**From:** [Biljan, Megan CIV USARMY CENWW \(US\)](#)  
**To:** [Schuster, Jarrett L CIV USARMY CENWW \(USA\)](#)  
**Cc:** [Martinez, Gregory J CIV USARMY CENWW \(US\)](#); [Colter, Anneli K CIV USARMY CENWW \(US\)](#)  
**Subject:** RE: City of Council Wastewater Improvement Project FONSI preparation (UNCLASSIFIED)  
**Date:** Thursday, January 17, 2019 11:21:02 AM

SUBJECT: NWW-2013-00164, City of Council Sewer Collection System Repair

ArcGIS map with USFWS Wetlands Data and proposed sewer line replacements  
Google Earth imagery map of lagoons and potential new discharge point (B)

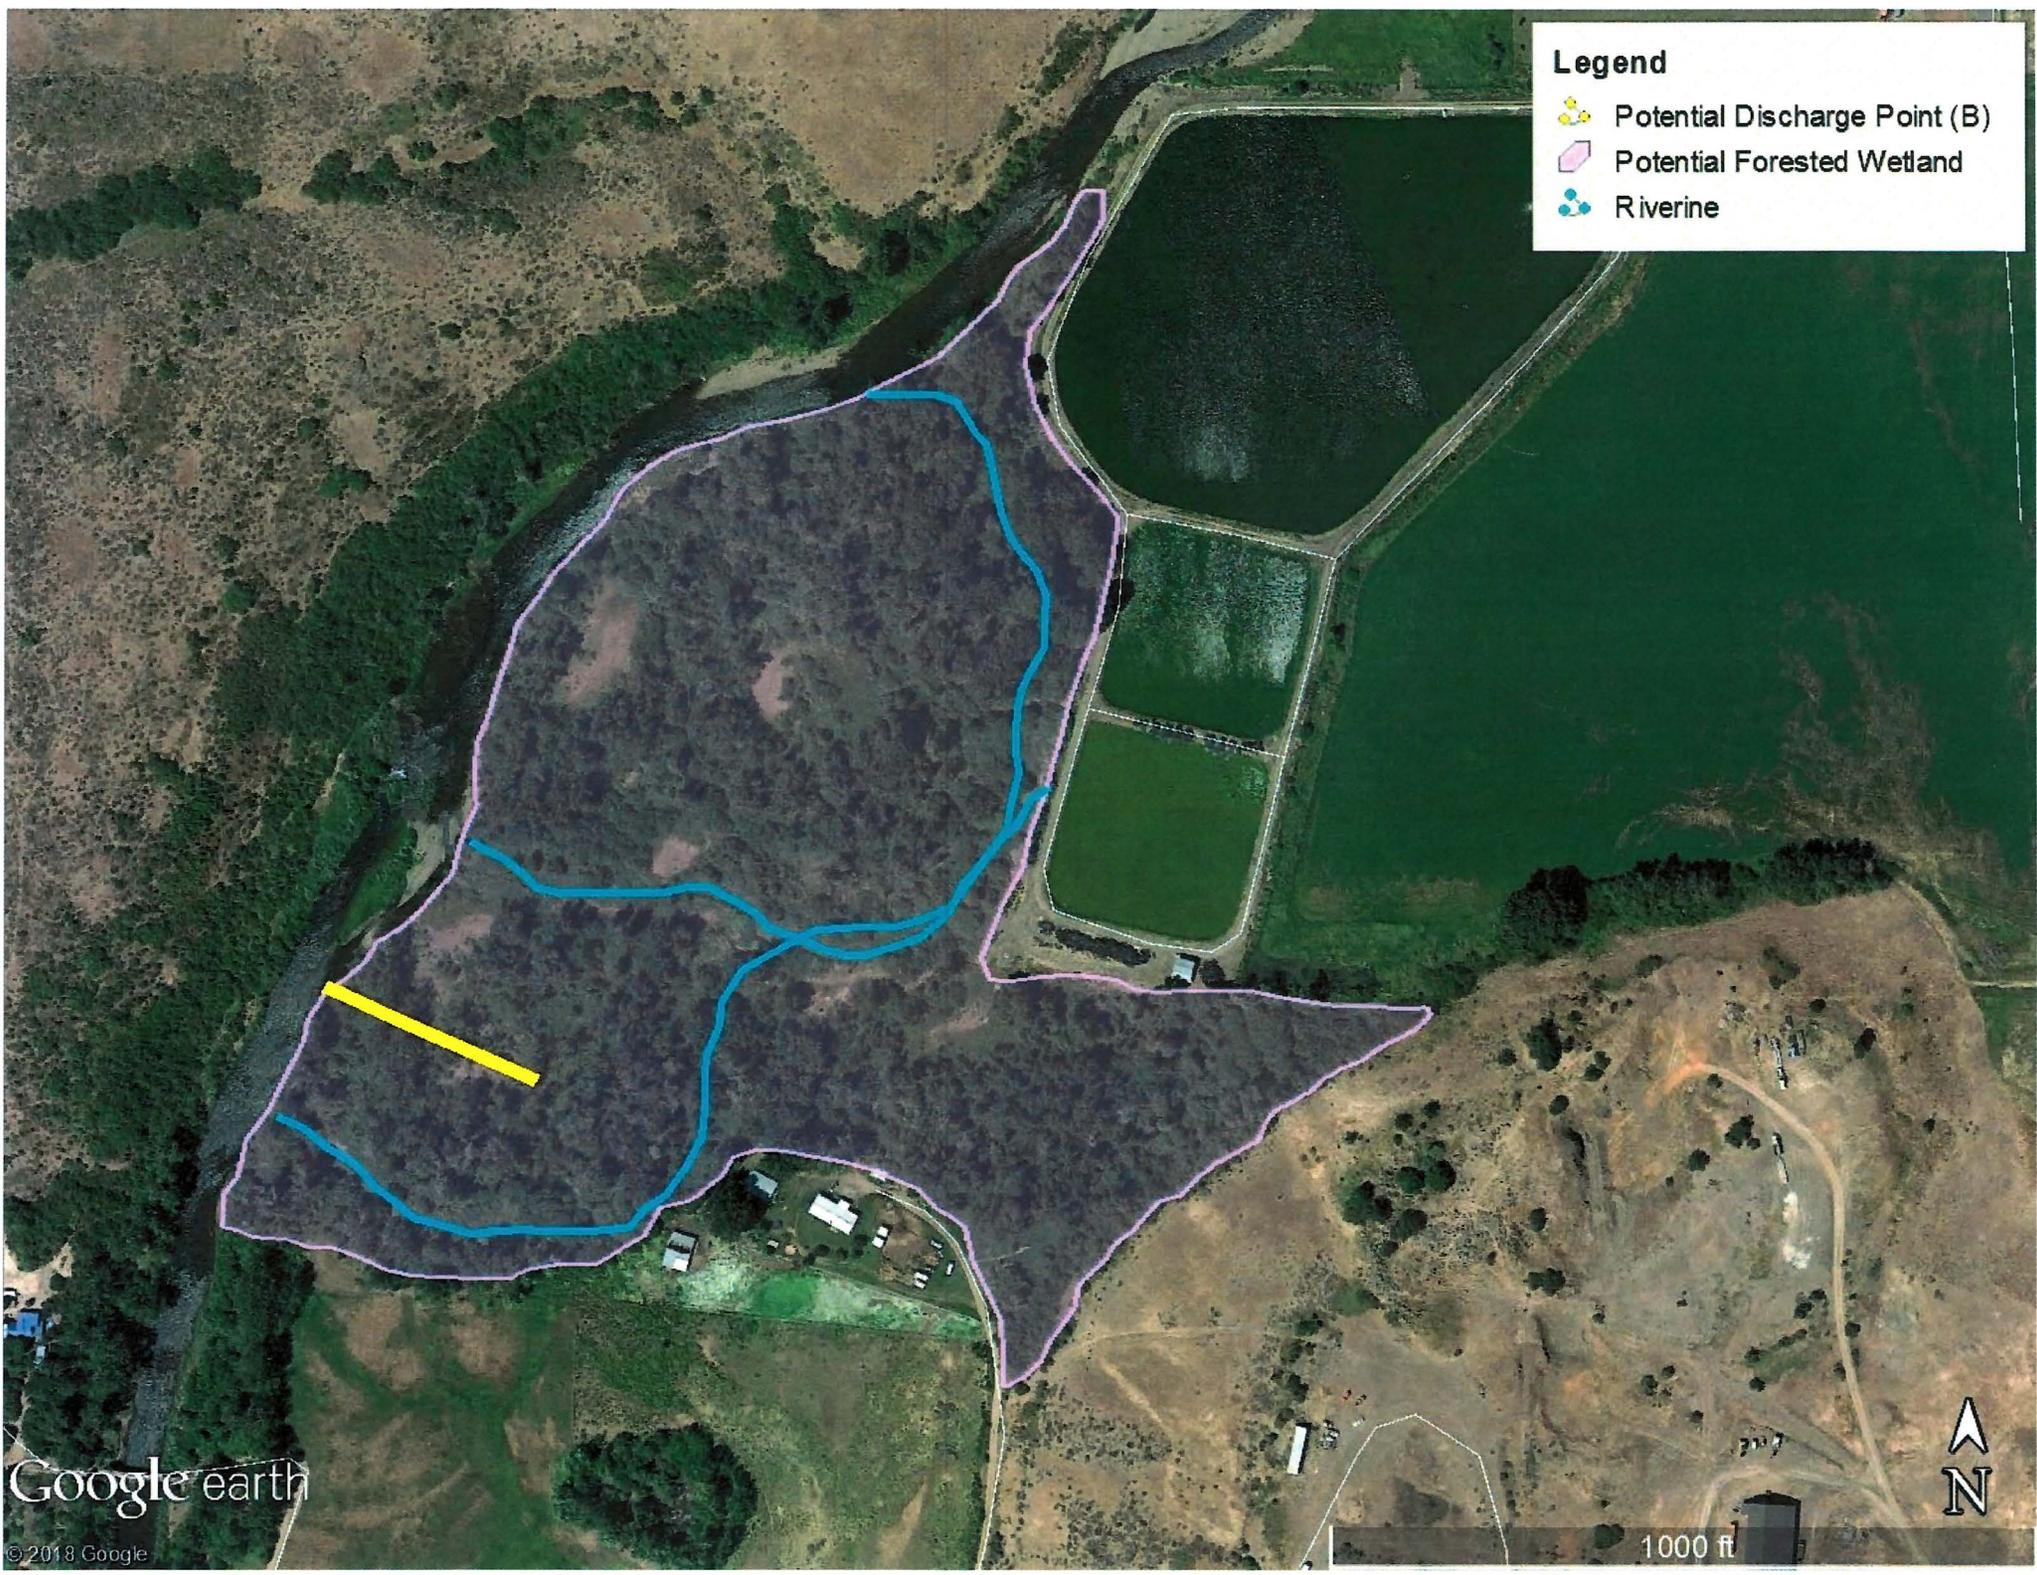
The two main concerns were the natural slough between the lagoons and the Weiser River and possible wetlands adjacent to the Weiser River. The response letter had some questions that need to get answered before we can complete our NEPA process. The letter is attached.

We have reviewed the information you furnished and other information available to our office. Based on the attached Google Earth imagery map and the National Wetlands Inventory ArcGIS Database Map (Review Date 05/09/18) a natural slough is located between the lagoons and the Weiser River, and there is the potential for wetlands adjacent to the Weiser River to be present in and around the proposed new discharge points where the lagoons currently exist. However, the site maps provided do not identify how utilities would be brought onto the site, or whether these waterways and/or wetlands would be impacted from roads that might be required for access and construction. The applicant should be made aware that any discharge of fill material into these waters would require a DA permit, however, until more detailed information is provided we cannot determine if a permit would be required from the Corps for this proposed project

Thanks for following up. The discharge point is not going to be moved. Due to the setup of the treatment process and elevations, a lift station would have to be added and the City does not want to add any pumping facilities! It makes things a lot easier in that everything will be contained fully within the existing treatment plant boundary.

No discharge of fill is planned or anticipated at any point, the existing banks of the lagoons will stay in place and be worked on from inside the lagoon.
